Town of Hilton Head Island

Board of Zoning Appeals Meeting

- **c. Public Hearing**
     APL-000429-2025 - Matthew Lewis is appealing an action to enforce the provisions of this Ordinance of the Official's approval of building permits for 35, 37, and 39 Oleander Street. The subject properties are located on Oleander Street, are zoned RSF-6 and are in the Holiday Homes Neighborhood Character Overlay District, and are known as Parcles 832, 833, 1106 on Beaufort County Tax Map 9.

TOWN OF HILTON HEAD ISLAND
PLANNING DEPARTMENT

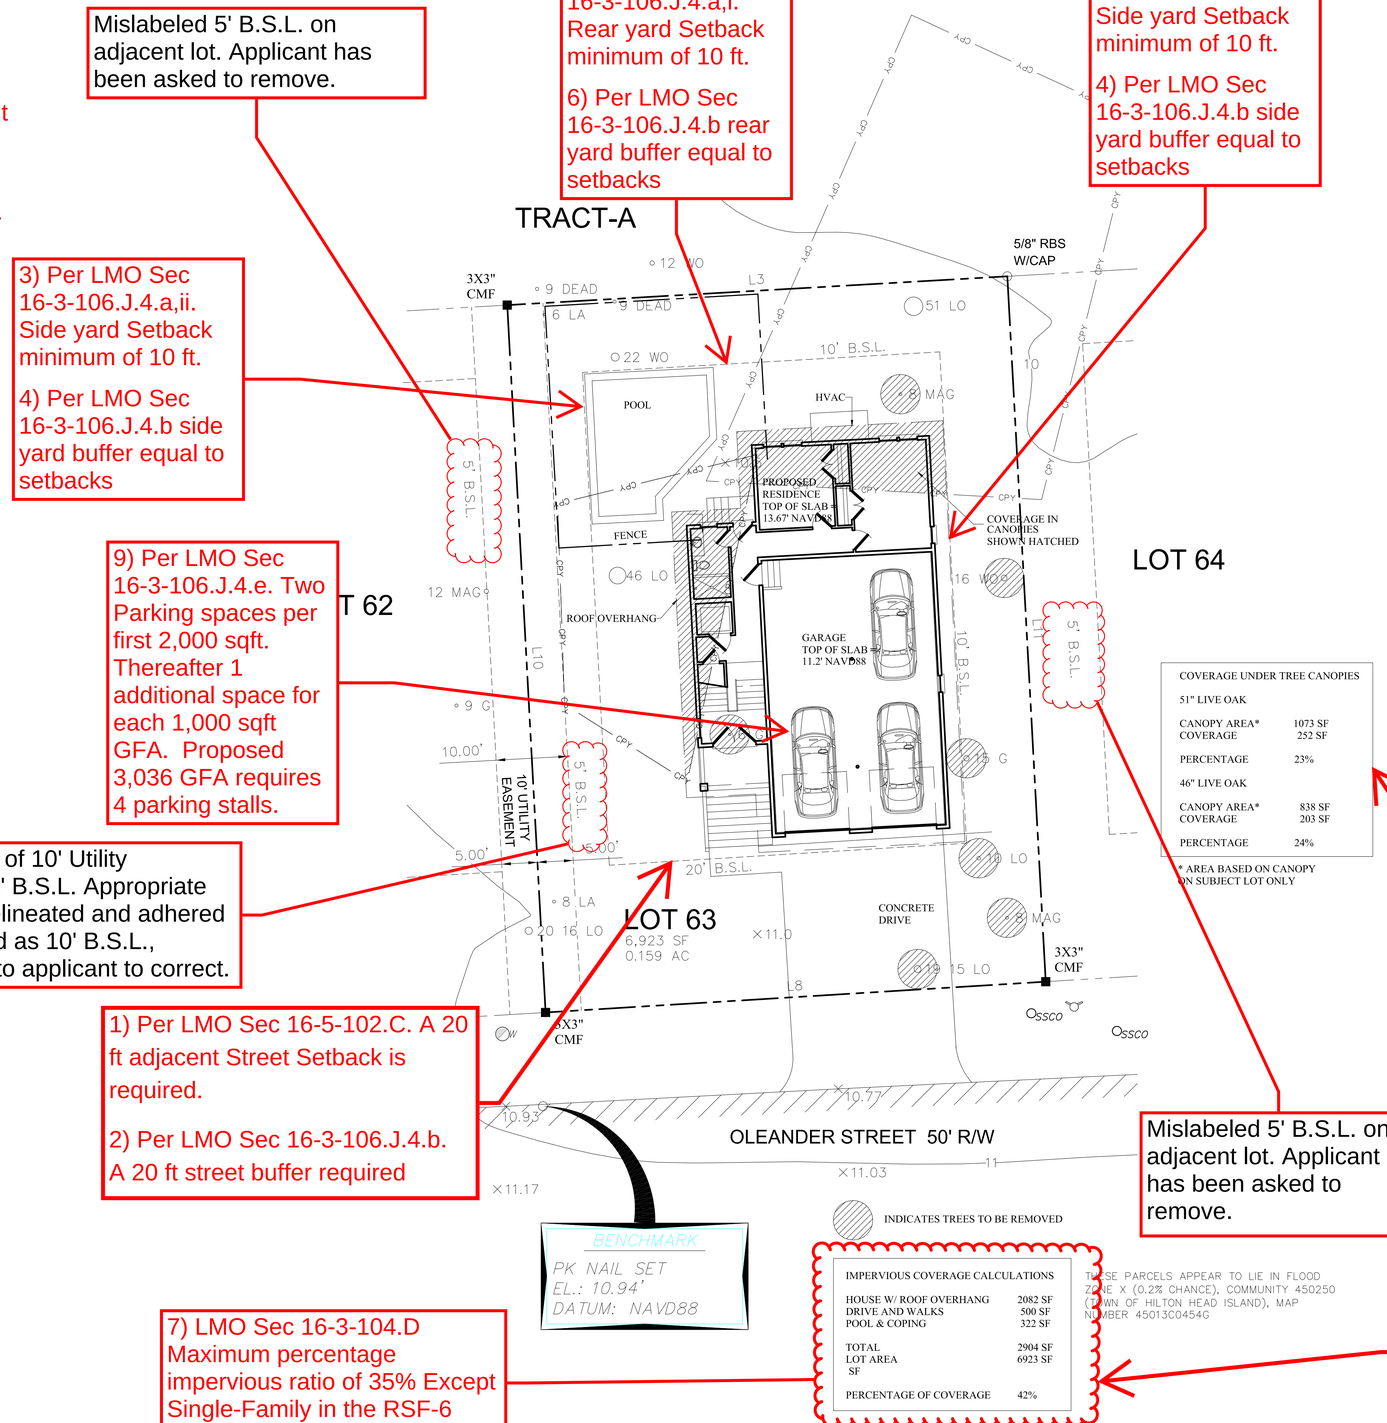
*Applicant will be required to submit Landscape Plan to show that buffers will be properly planted per the LMO. The Adjacent Street Buffer should meet the standards of LMO Section 16-5-103.D for Other Streets, which is a Type A Option 1 Buffer, while the Adjacent Use Buffers should meet the requirements of LMO Section 16-5-103.E for Single Family proposed against Single Family or Multifamily, which is a Type A Option 2 Buffer.

Mislabeled 5' B.S.L. on adjacent lot. Applicant has been asked to remove.

5) Per LMO Sec 16-3-106.J.4.a,i. Rear yard Setback minimum of 10 ft.

1 A3 FRONT ELEVATION
1/4"=1'-0"

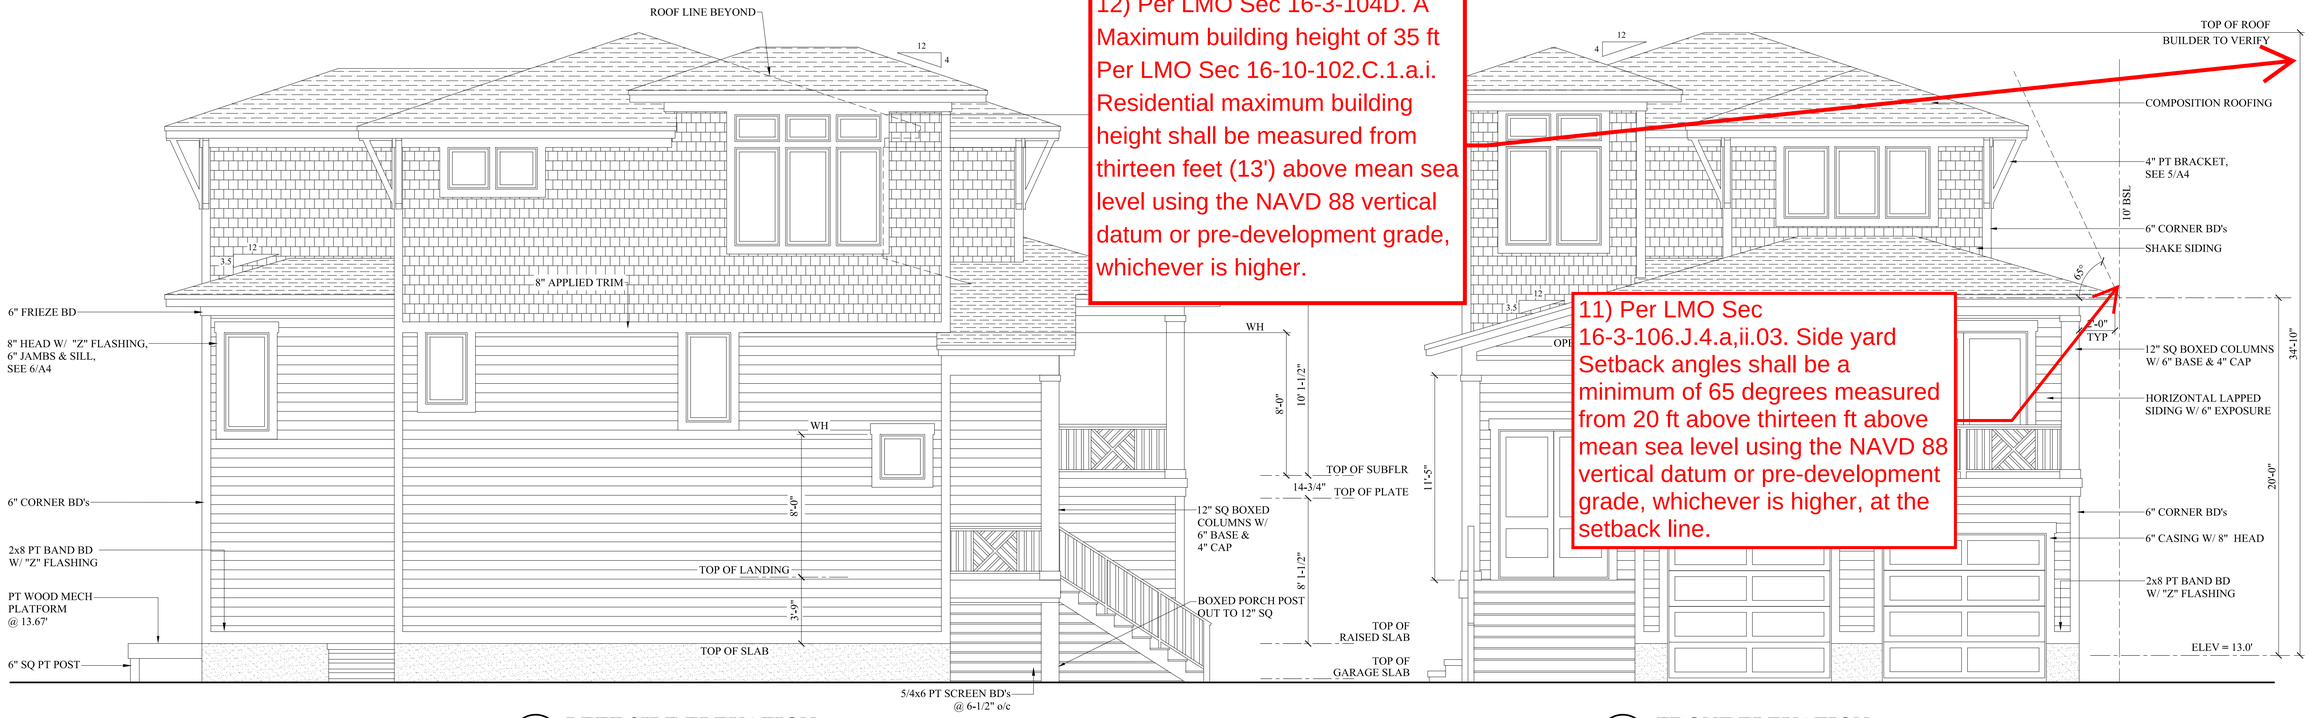
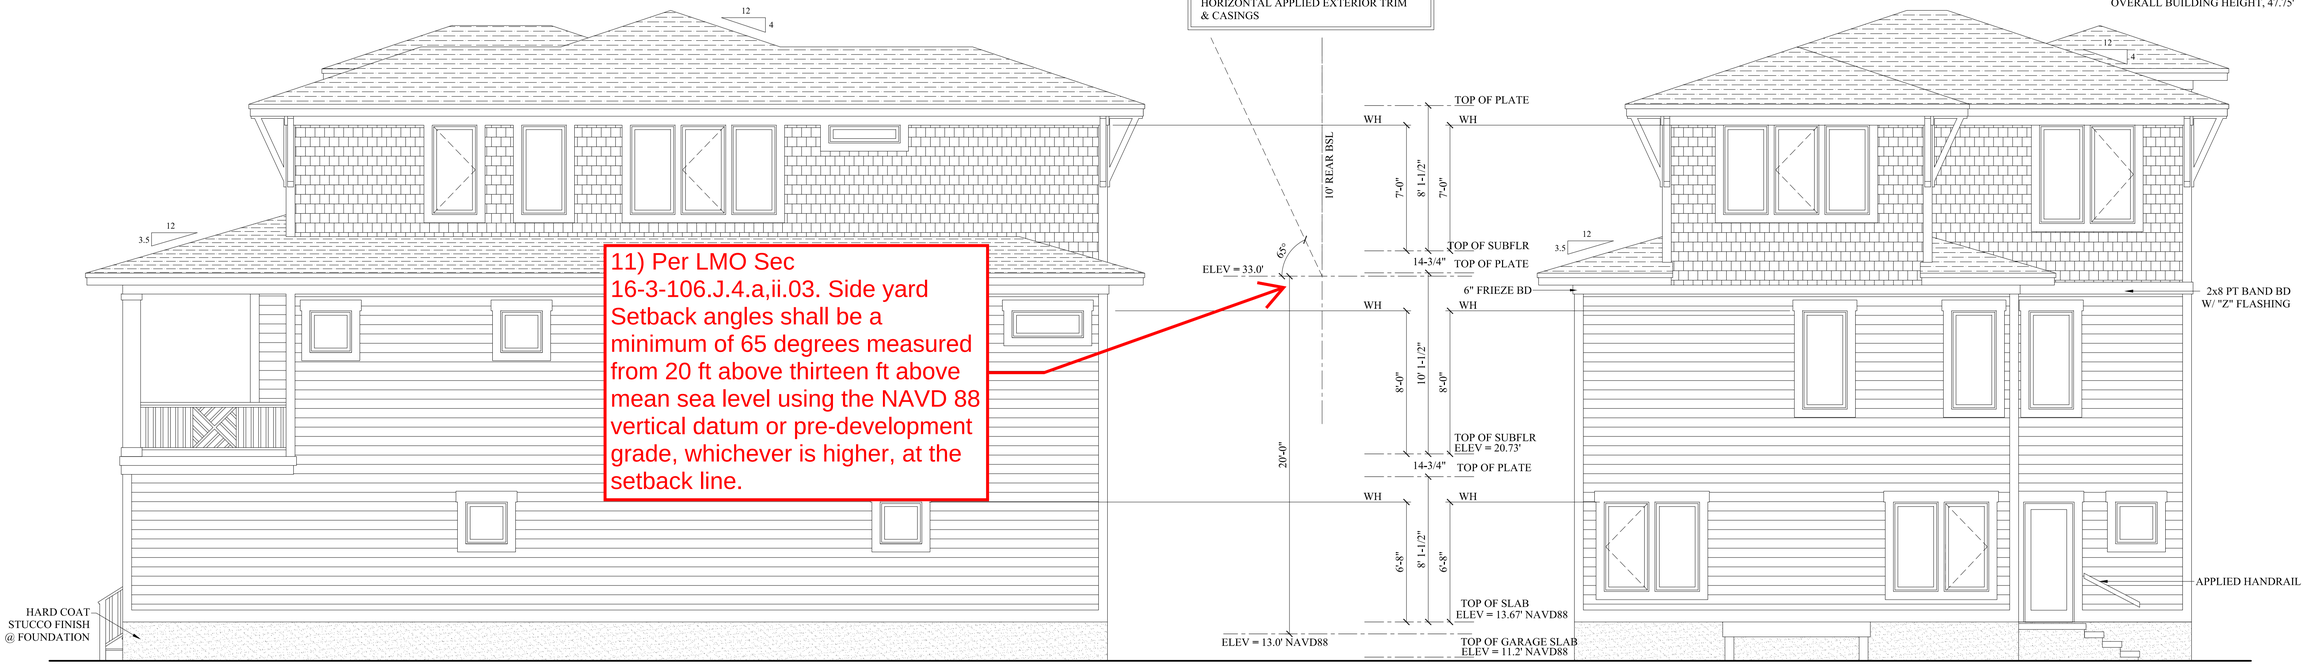
12) Per LMO Sec 16-3-104D. A Maximum building height of 35 ft Per LMO Sec 16-10-102.C.1.a.i. Residential maximum building height shall be measured from thirteen feet (13') above mean sea level using the NAVD 88 vertical datum or pre-development grade, whichever is higher.

11) Per LMO Sec 16-3-106.J.4.a,ii.03. Side yard Setback angles shall be a minimum of 65 degrees measured from 20 ft above thirteen ft above mean sea level using the NAVD 88 vertical datum or pre-development grade, whichever is higher, at the setback line.

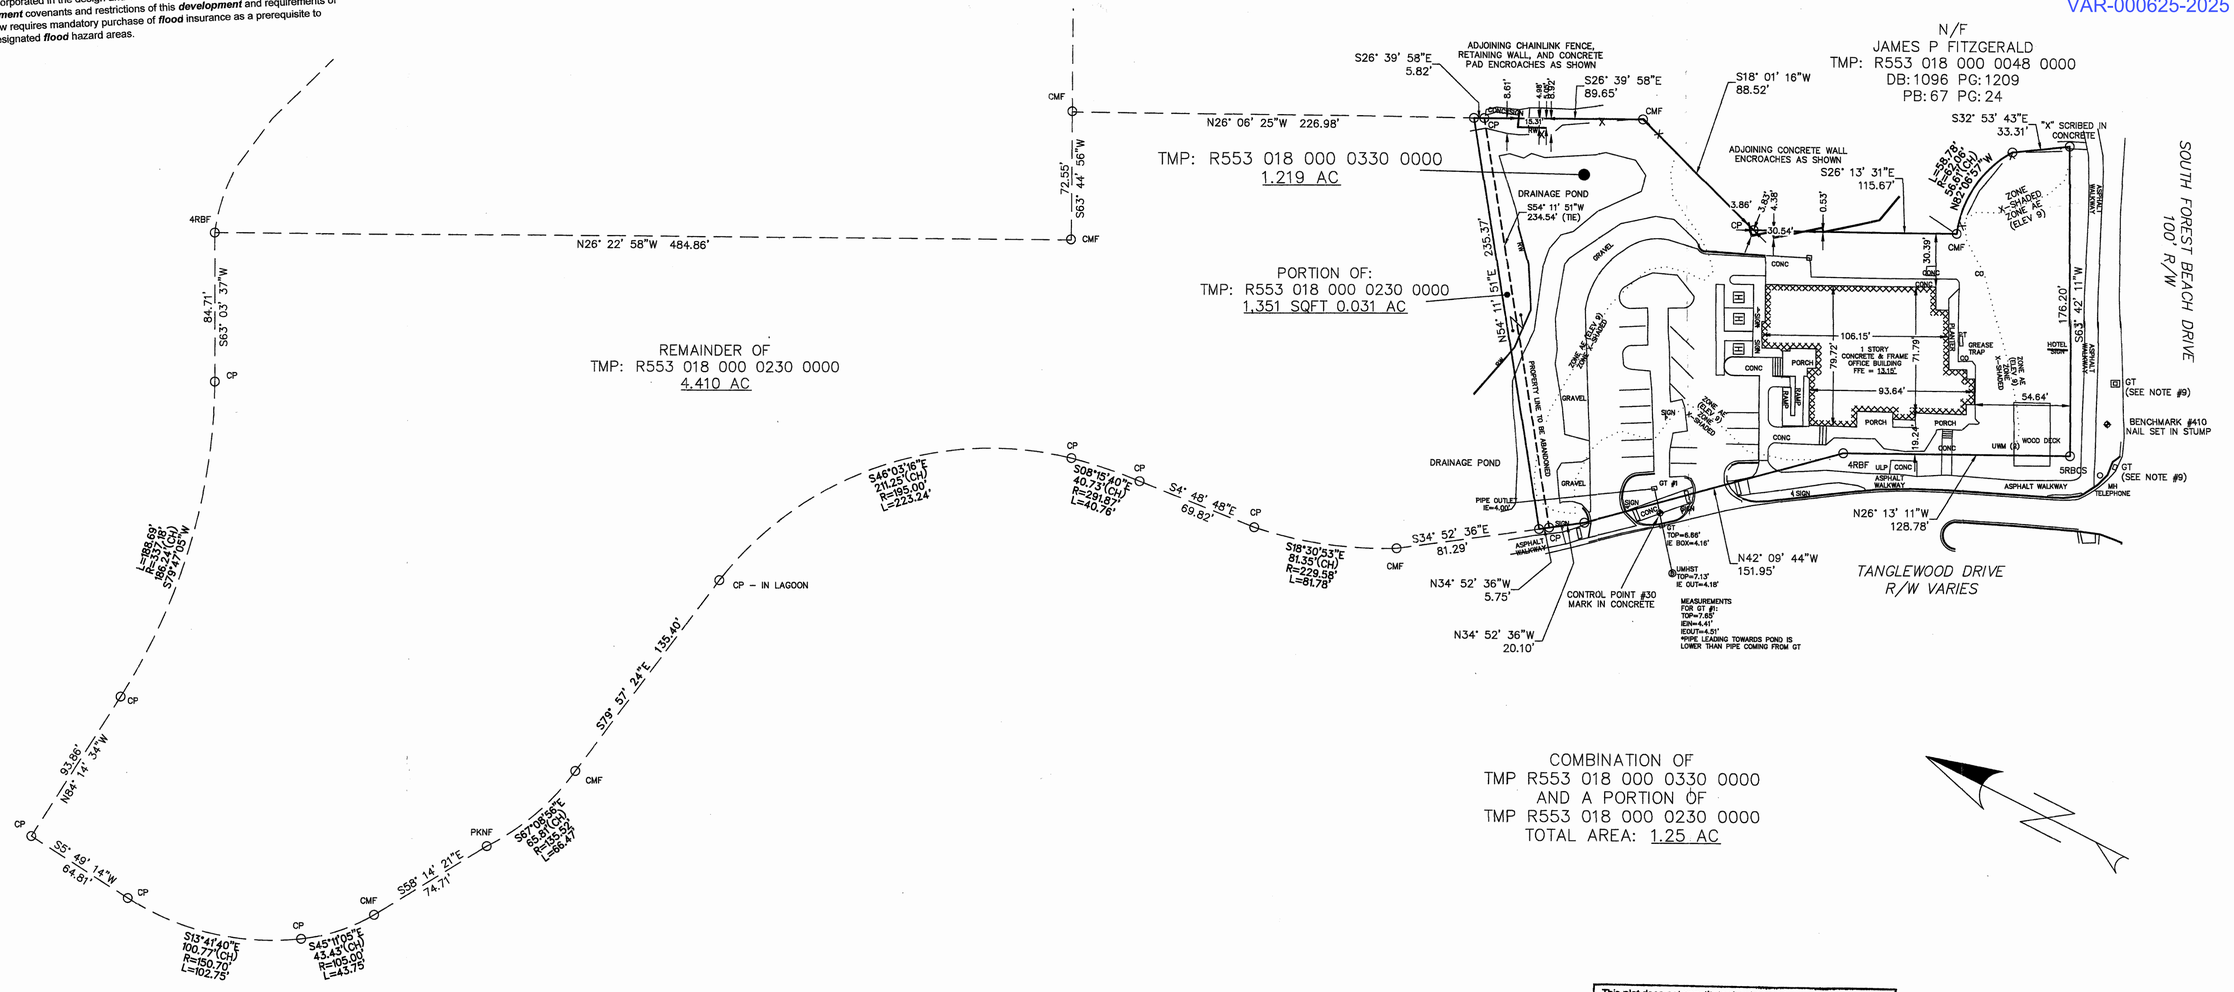
75. Correction: Parking design requirements outlined in 16 5 107.E.1 or 16 5 107.E.2 shall be satisfied relative to required stall dimensions or backing area dimensions. 10 feet if the parking space adjoins a median that is located at the end of a parking bay or separates parking spaces within a

76. Correction: Provide parking layout for under building lot.
